H11493

## DESCRIPTIVE REPORT

Project OPR-P132-RA-05  
Eastern Prince William Sound, AK  
Scale 1:10,000  
September - October 2005  
**NOAA Ship RAINIER (S221)**  
Chief of Party: Commander Guy T. Noll, NOAA

## Revisions Compiled During Office Processing and Certification

Figure 2. Reef extents overruled.

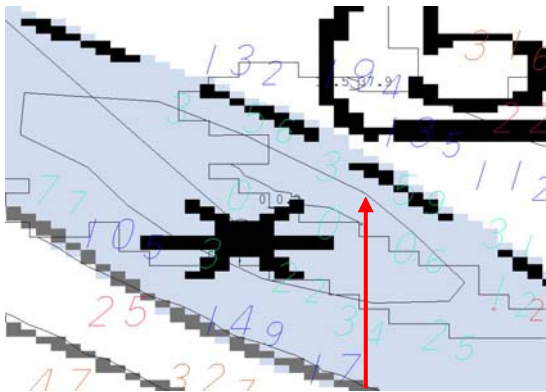
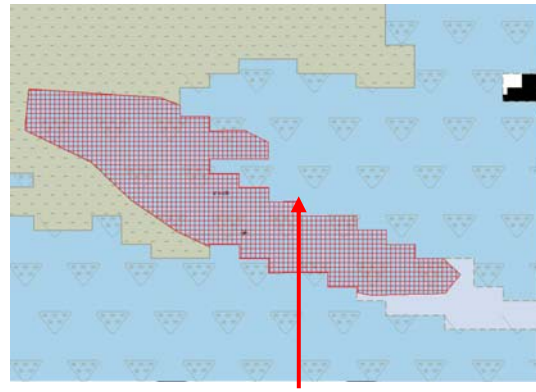
Manual digitizing of some of the new reefs by the field unit led to discrepancies in the true representation of their extents, Figure 1. During office processing, hydrography and the limits of the hydrographic coverage were used to refine the reef extents, as in the example, Figure 2.
